SHAWNEE PASS ASSESSMENT DISTRICT 2025, NAKOMA SIDEWALK, AND NAKOMA CULVERT

CITY PROJECT NO. 11822
CONTRACT NO. 8783

- ADDENDUM #1 - 4/8/25
REVISED THE FOLLOWING:
D-3, D-5, P-5, U-5, U-7
- REVISION #1 - 7/8/25
REVISED THE FOLLOWING:
P1-P5
- REVISION #2 - 7/29/25
REVISED THE FOLLOWING:
D3, D4, U5, U6, U9

11822	MADISON, WI	8783	CONTRACT NO:
SHAWNEE PASS PLAN & PROFILE			
SHAWNEE PASS, NAKOMA SIDEWALK, AND NAKOMA CULVERT			
M:\DESIGN\Projects\11822\CAD\Streets\11822EN-PnP.dwg			
11822			
P-1

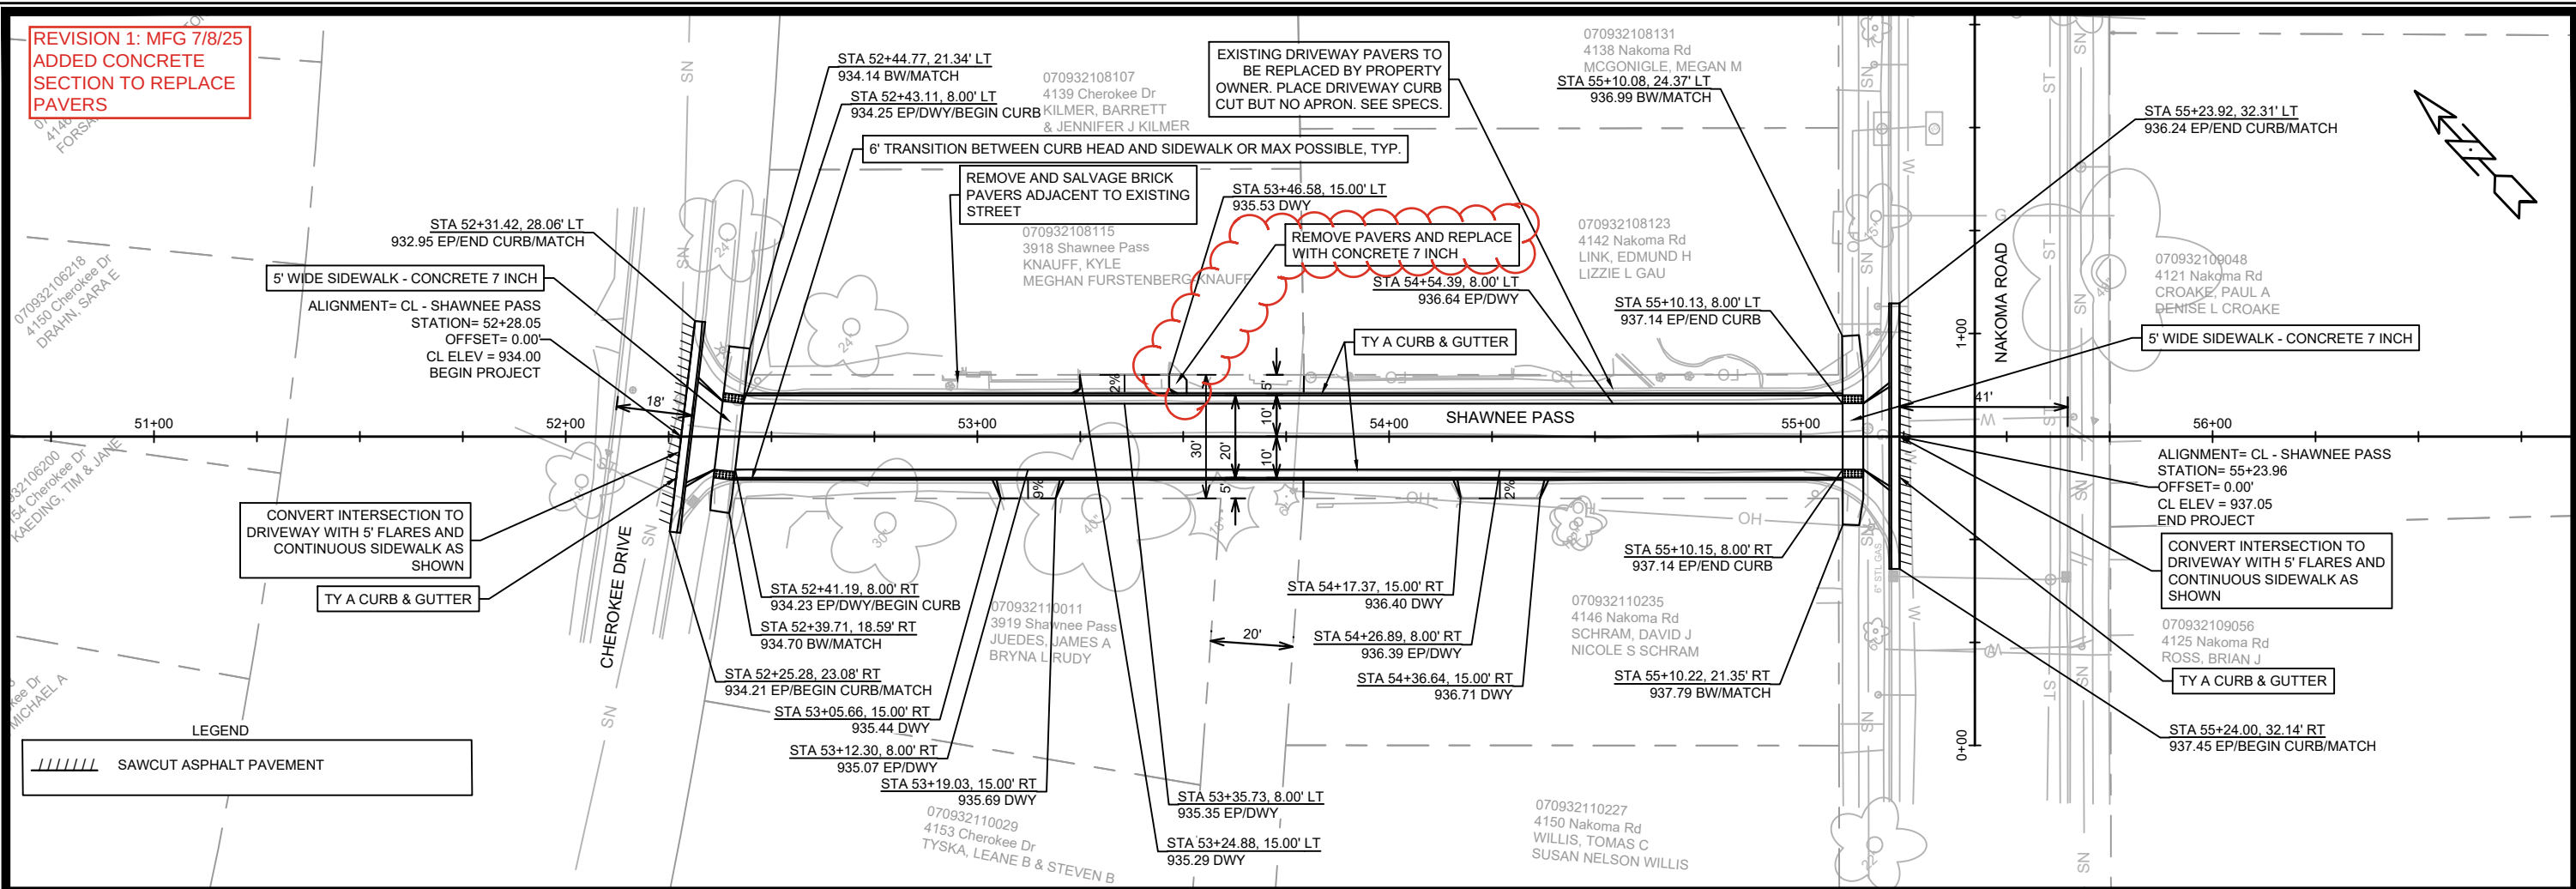
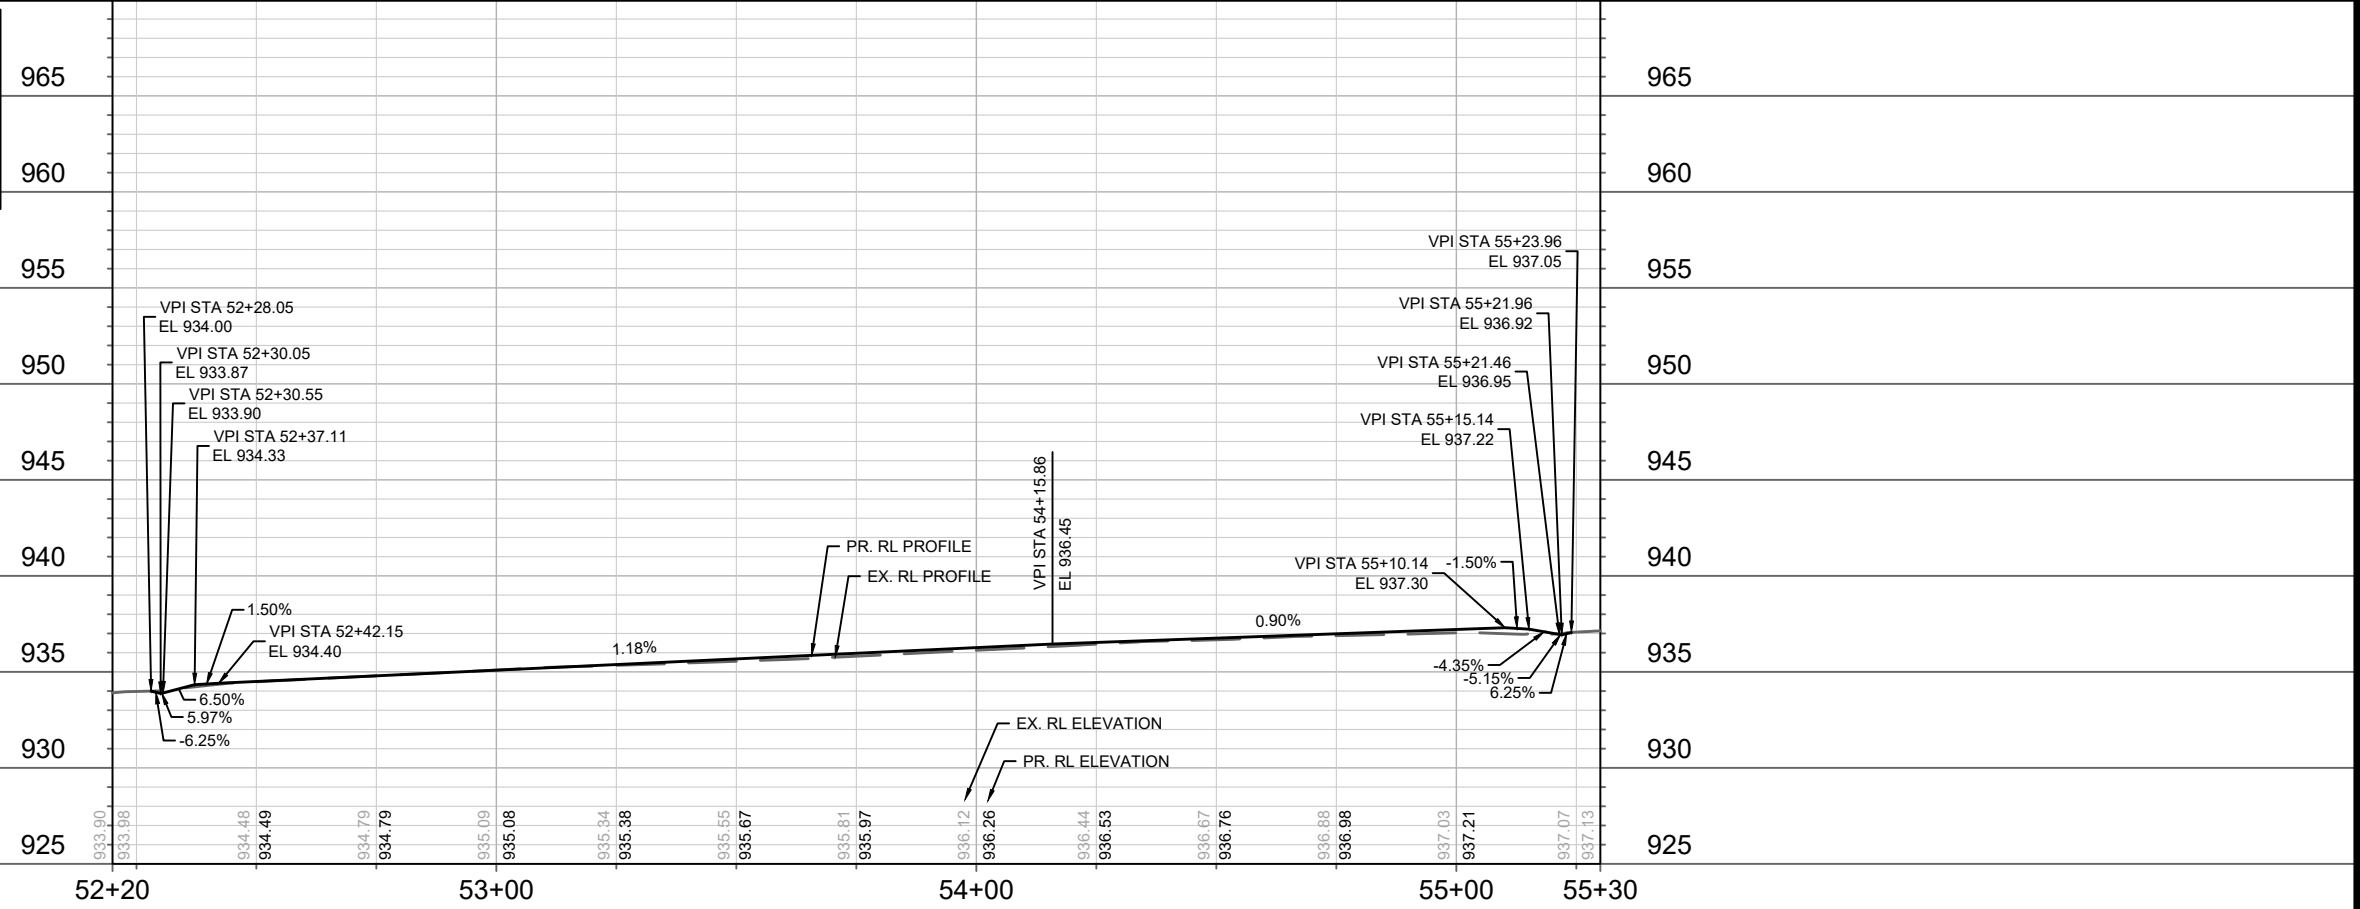
REVISION 1: MFG 7/8/25
ADDED CONCRETE
SECTION TO REPLACE
PAVERS

11822	MADISON, WI	CONTRACT NO: 8783
NAKOMA ROAD SIDEWALK PLAN & PROFILE		
SHAWNEE PASS, NAKOMA SIDEWALK, AND NAKOMA CULVERT		
M:\DESIGN\Projects\11822\CAD\Streets\11822EN-PnP.dwg		
11822		
P-3

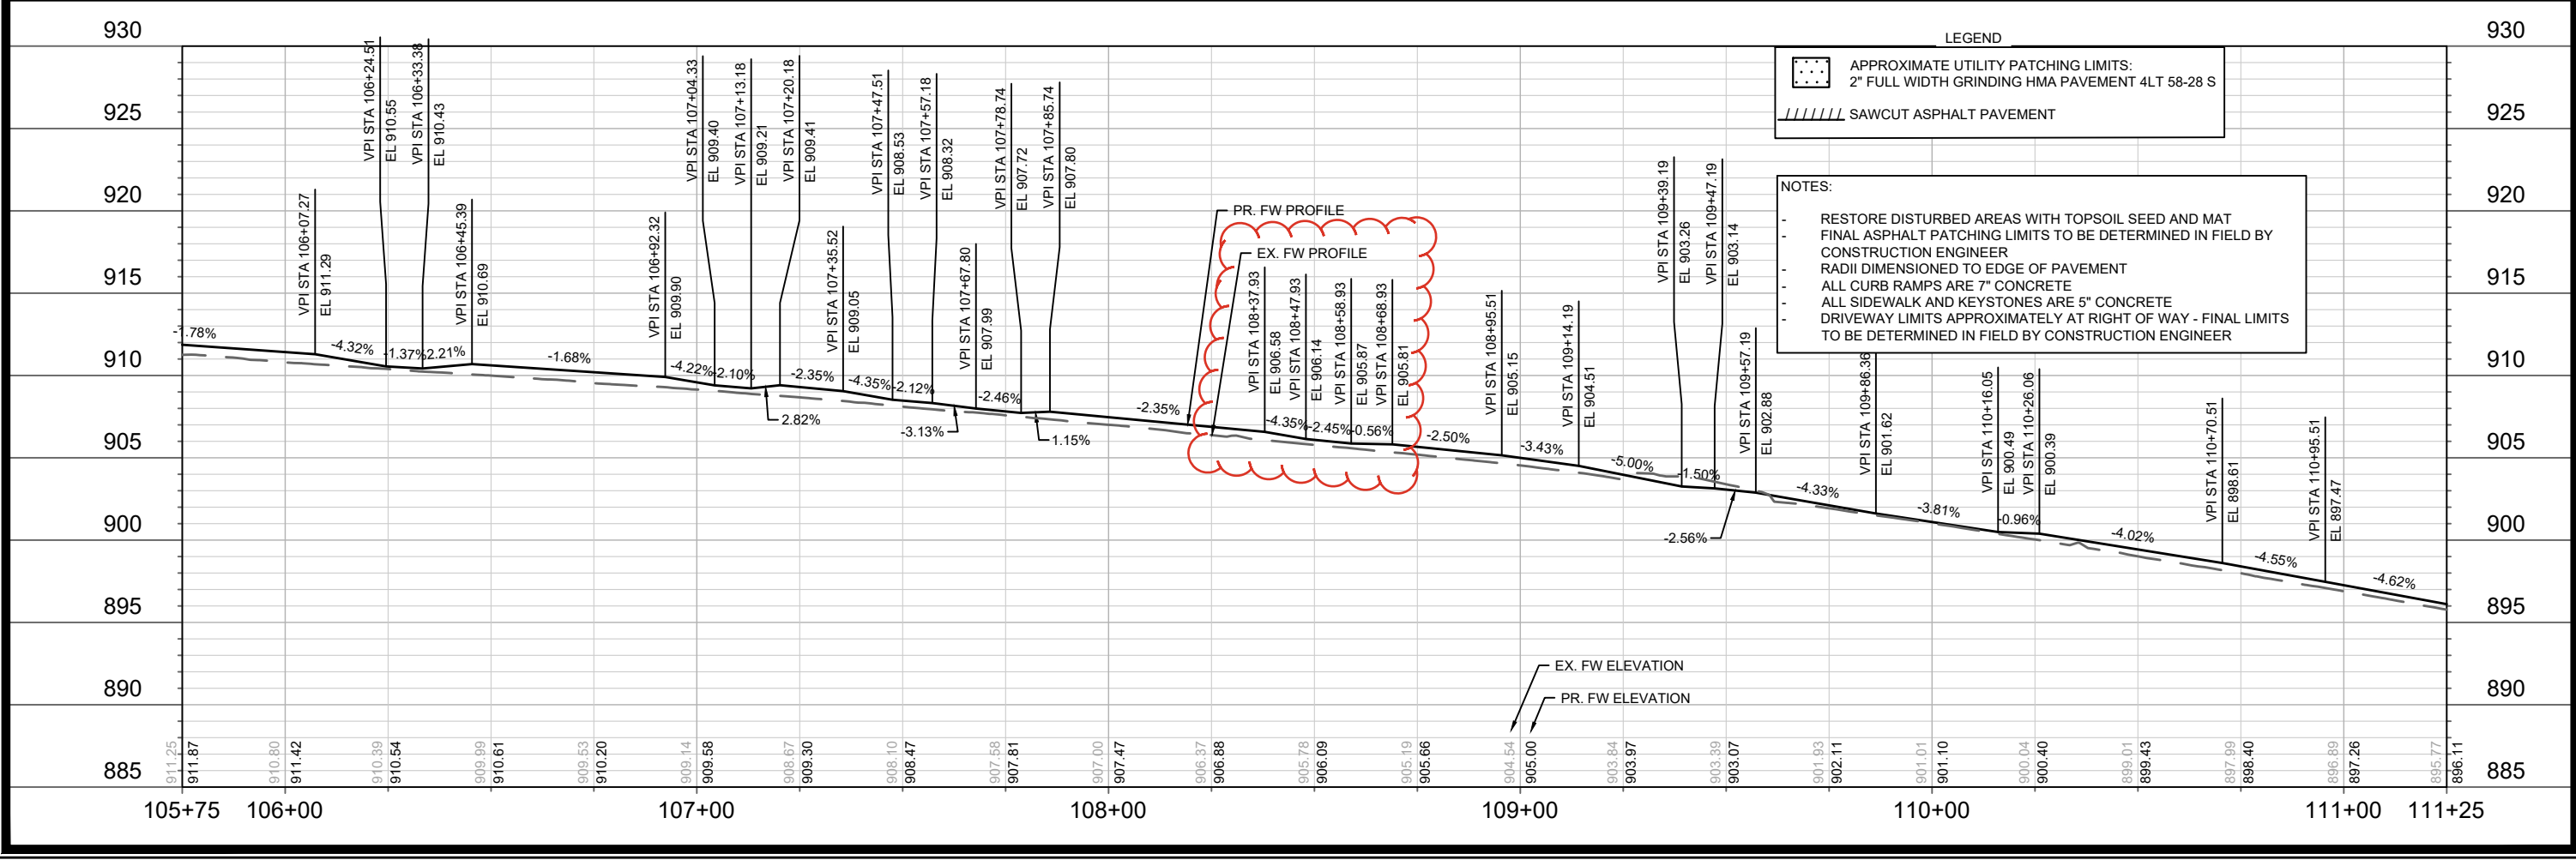
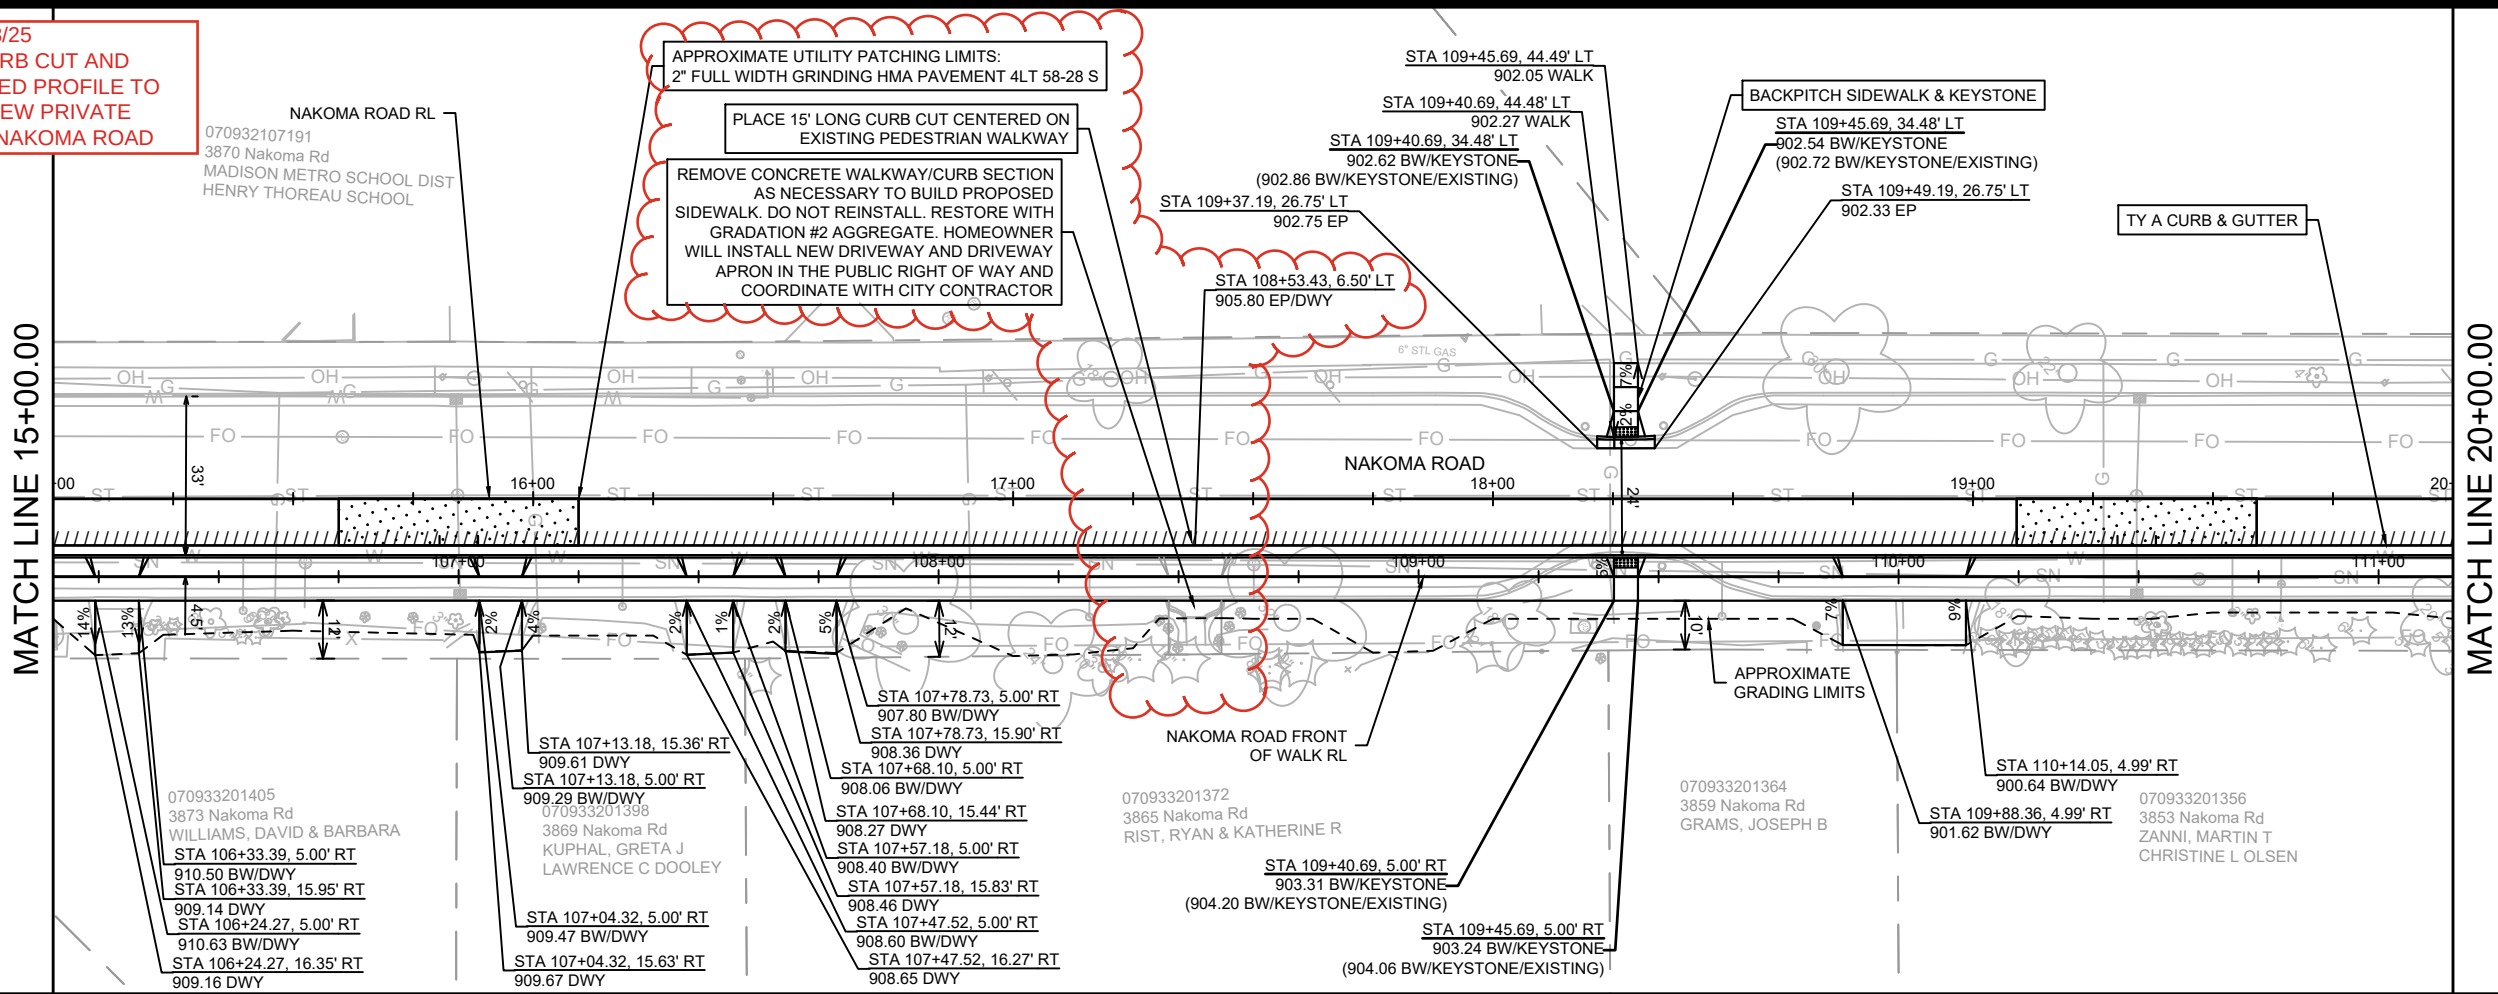
REVISION 1: MFG 7/8/25
ADDED 15' LONG CURB CUT AND
ADJUSTED PROPOSED PROFILE TO
ACCOMMODATE A NEW PRIVATE
DRIVEWAY AT 3865 NAKOMA ROAD
